Handling loss of signal in the ILT/RTS functions – part 2

Background

Proposed changes

Figure 178B-10a—Training control state diagram, part 1

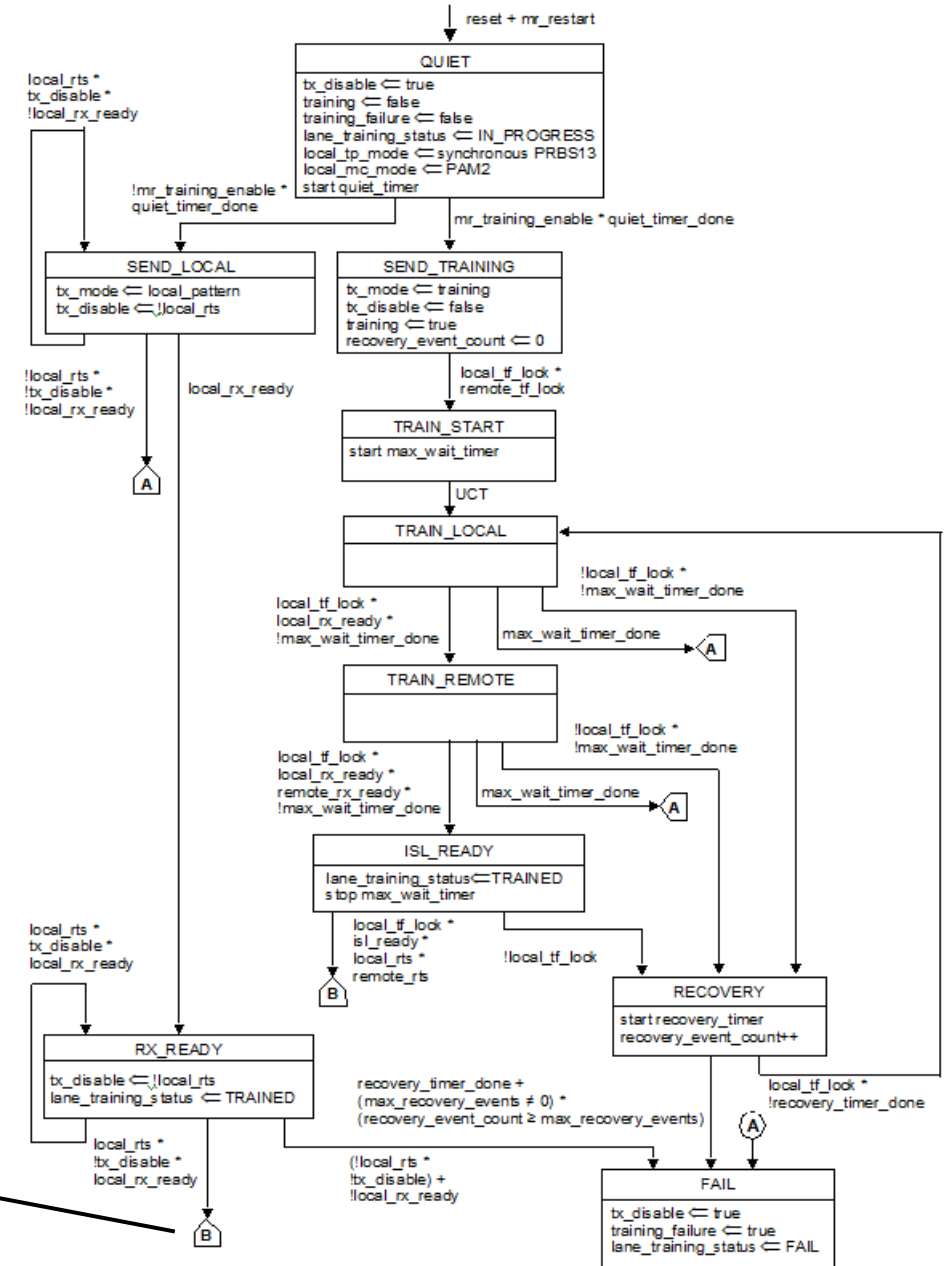
Split the training control state diagram into two parts

This is “part 1” (Figure 178B-10a)

Note: No technical change in the states above PATH_READY (represented by the “B” pointers)

Figure 178B-10b—Training control state diagram, part 2

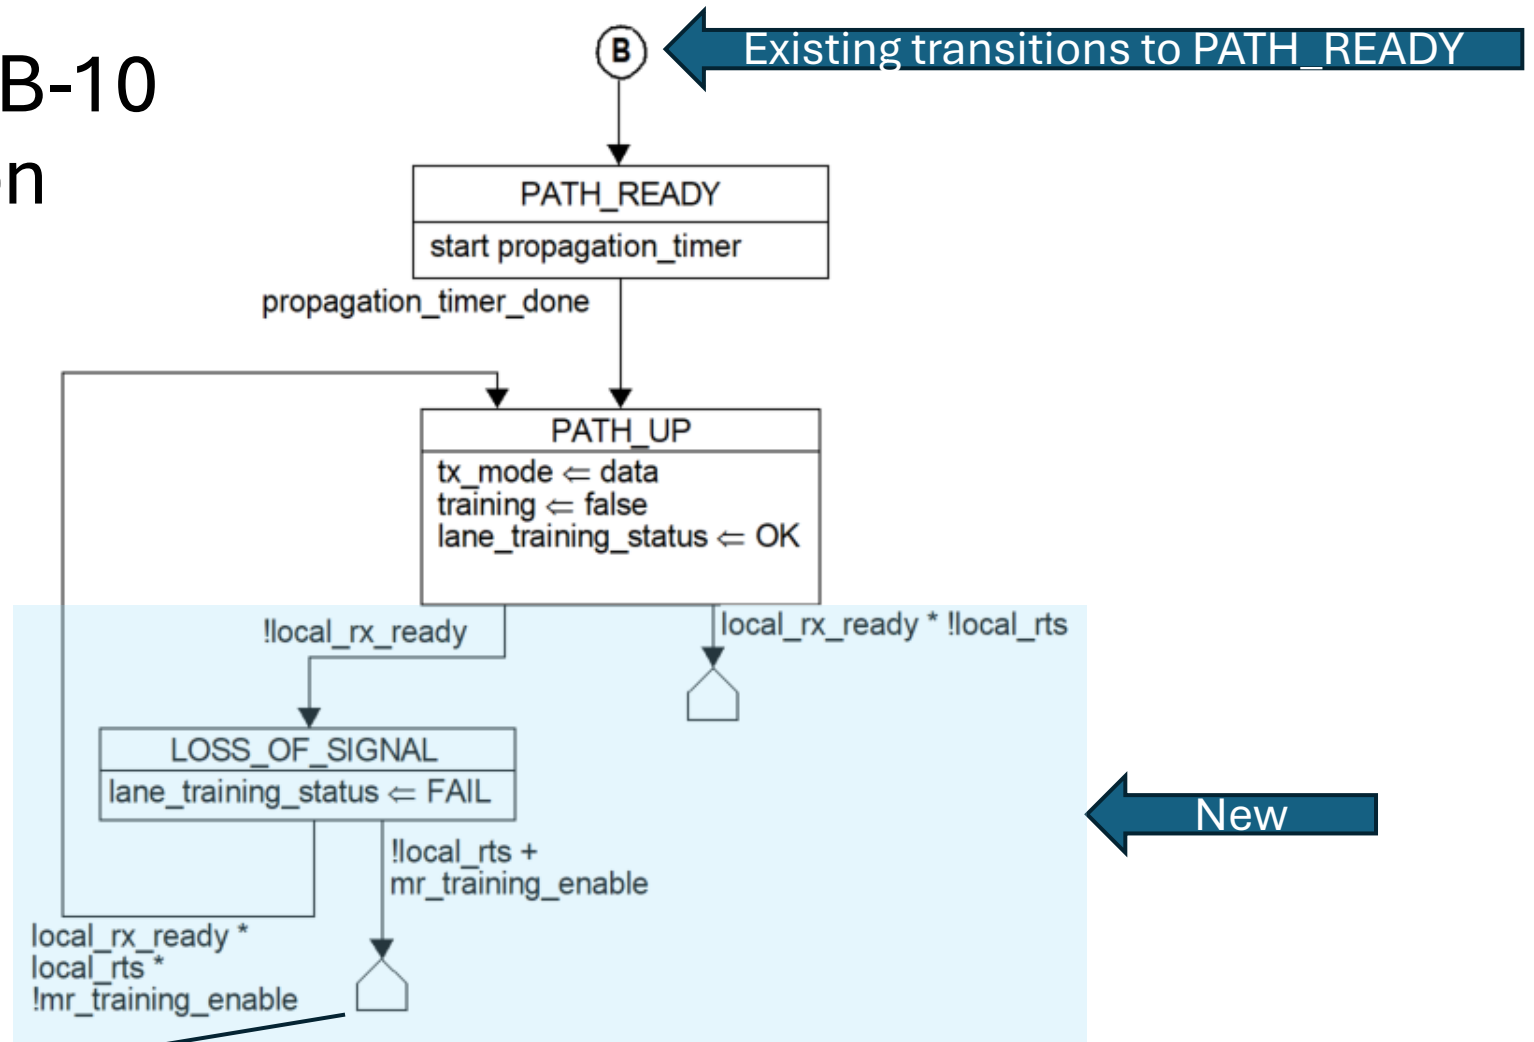
Additions to Figure 178B-10 to enforce a restart upon LOS

Option X

Auto restart: transitions to QUIET
 “Managed” restart: transitions to FAIL

Figure 178B-10b—Training control state diagram, part 2

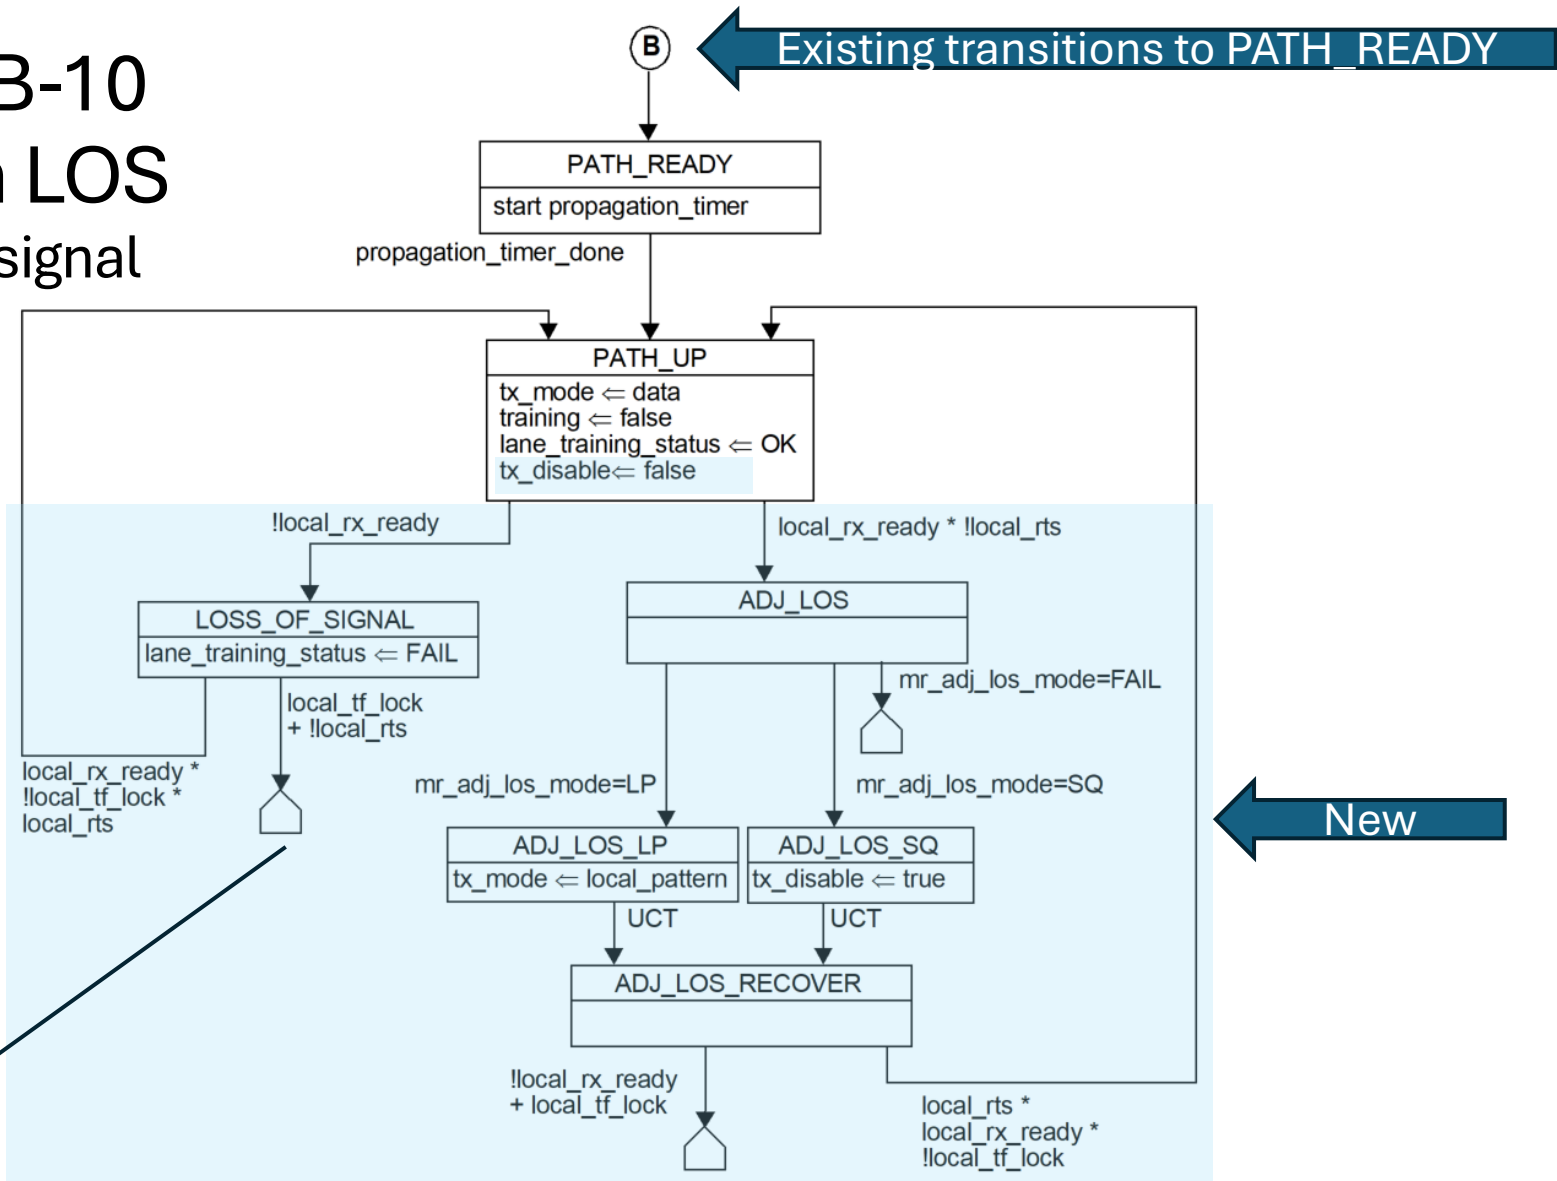
Additions to Figure 178B-10 to enable recovery from LOS (using squelch or replacement signal on adjacent interface)

Option Y

Auto restart: transitions to QUIET
 “Managed” restart: transitions to FAIL

mr_adj_los_mode

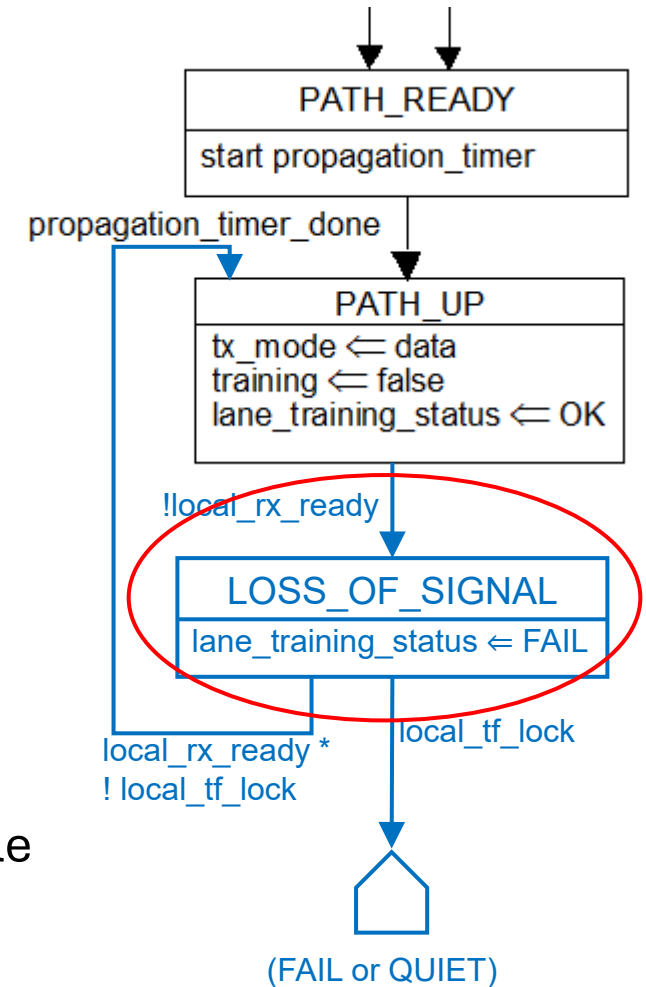
Enumerated variable that controls the behavior of the training control state diagram (Figure 178B-10) in PATH_UP state when local_rts becomes false. This variable is assigned by management and can take one of the following values: FAIL, SQ, or LP. The default value is FAIL. Implementation of the behavior corresponding to either of the values SQ and LP is optional.

NOTE—Setting mr_adj_los_mode to SQ or LP might not be compatible with all peers.

addition to Figure 178B–10

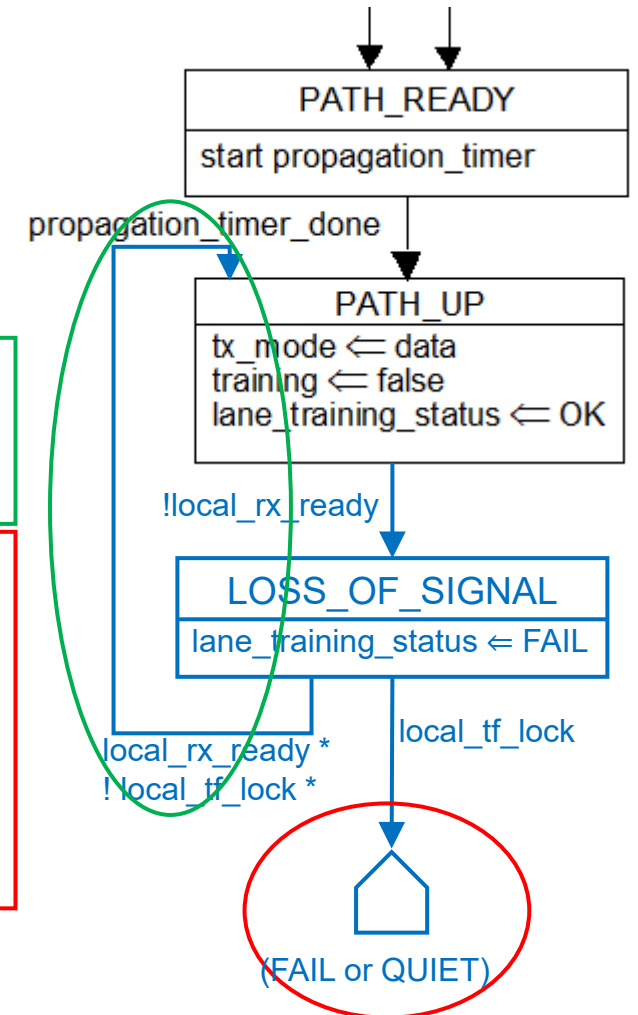
Recovery from LOS at the input of this interface

- Signal re-appearing is indicated by local_rx_ready
 - The timing and conditions to declare local_rx_ready is not specified. It should indicate “good data”.
- If the signal is not training frames (likely, mission data):
 - Return to PATH_UP
 - lane_training_status=OK propagates through service interface
- If it is training frames:
 - This means positively that the peer has restarted training
 - We must restart training too (no other way to recover)
 - Transition to FAIL, which requires mr_restart to exit
 - Note: indicated in the diagram as local_tf_lock, but could be detected by other means, e.g. not detecting AMs.
- Management can always restart training (mr_restart)
 - For example, if the signal does not re-appear within some time
 - Management can also decide to restart upon entry to LOSS_OF_SIGNAL

LOS at the input to the adjacent interface – solution – option X

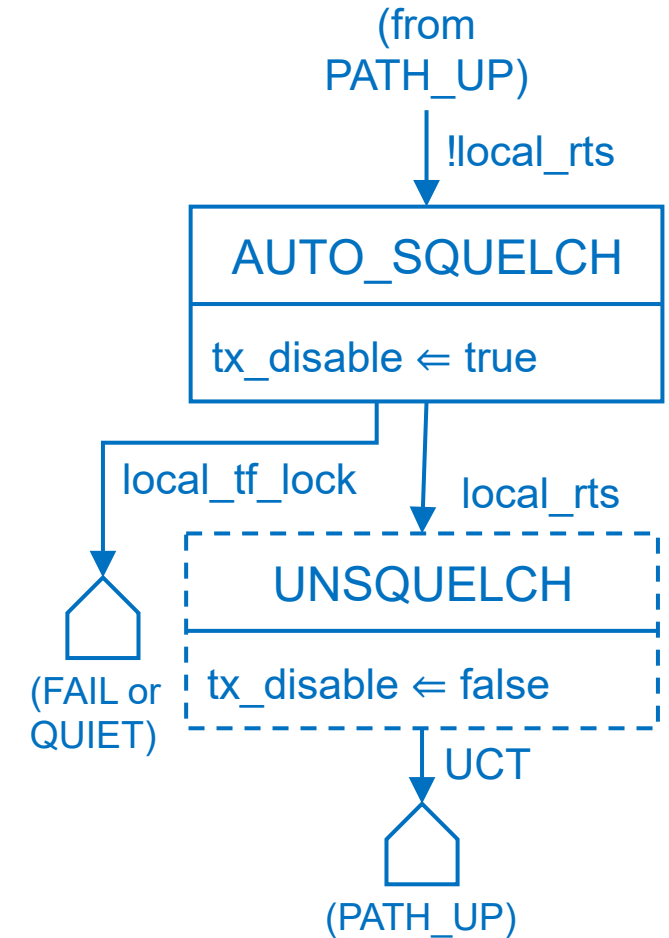
- Make restart of training (via FAIL or QUIET) the specified behavior.
 - If training is enabled, fail both local and adjacent interface.
 - If training is disabled, fail only the adjacent interface.
- If transition is to FAIL, the interface will stop transmitting and indicate the status. Management is responsible for completing the restart.
- Adds one state + one new transition to the training control state diagram.

LOS at the input to the adjacent interface – solution – option Y2 (local pattern)

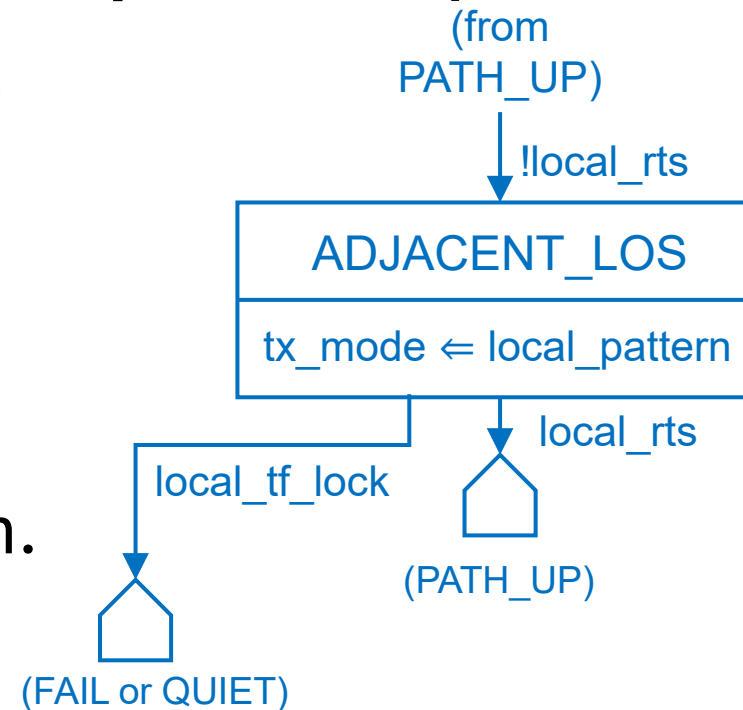
Similar to solution #1 but instead of squelching, switch to transmitting a **local pattern** when local_rts is de-asserted.

This happens after the transition to local_clock in the RTS state diagram.

When local_rts is back, return to PATH_UP (in which tx_mode is set back to data).

Figure 178B-9—RTS update state diagram

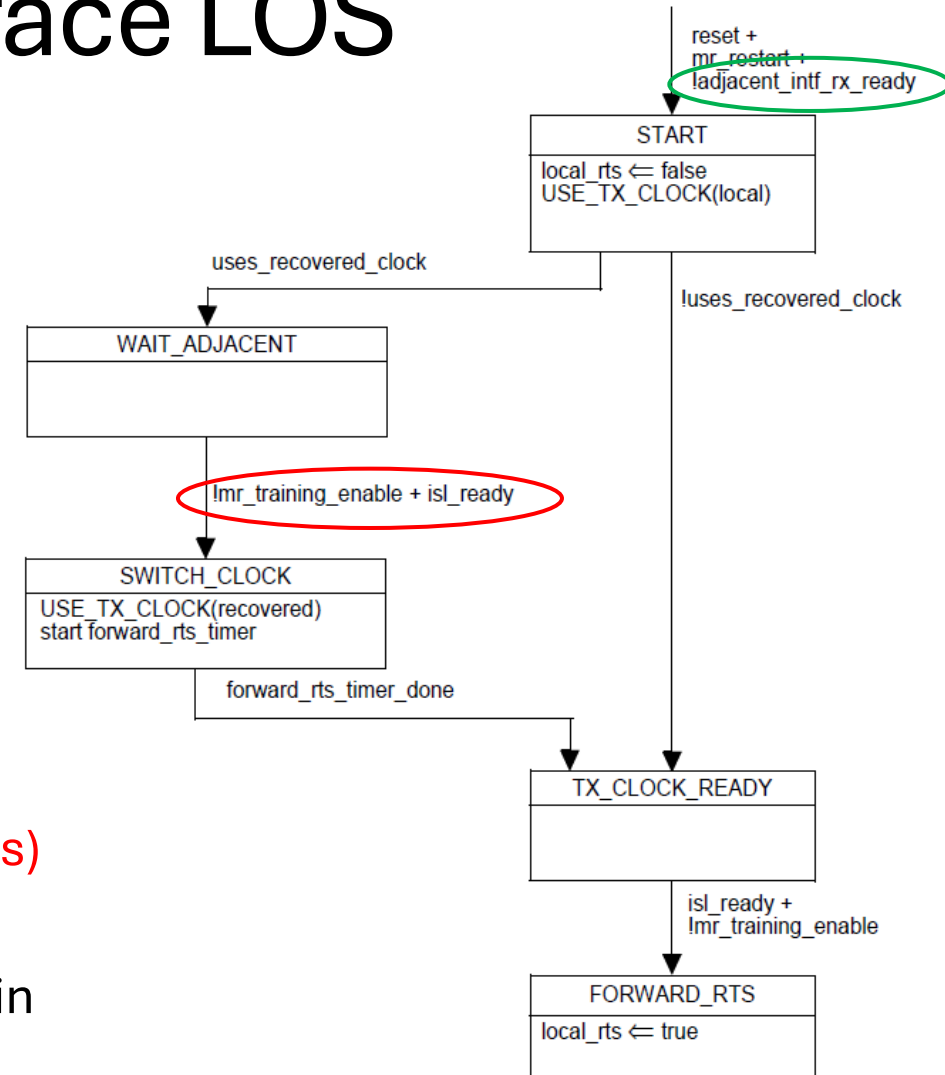
- When SIGNAL_OK on the service interface (from the adjacent interface) recovers to OK...
 - **adjacent_intf_rx_ready becomes true**
 - The RTS update state diagram advances from START
- The state diagram needs to set local_rts=true to make the local interface unsquelch ([slide 20](#)).
- If **mr_training_enable=false**, the transition is unconditional.
- But if **mr_training_enable=true**:
 - If a recovered clock is used (module/retimer) it needs **isl_ready (local_rx_ready * remote_rx_ready on all lanes)** to advance to SWITCH_CLOCK
 - In data mode, training frames are not received, so **remote_rx_ready** is irrelevant. It should be set to true in its definition.
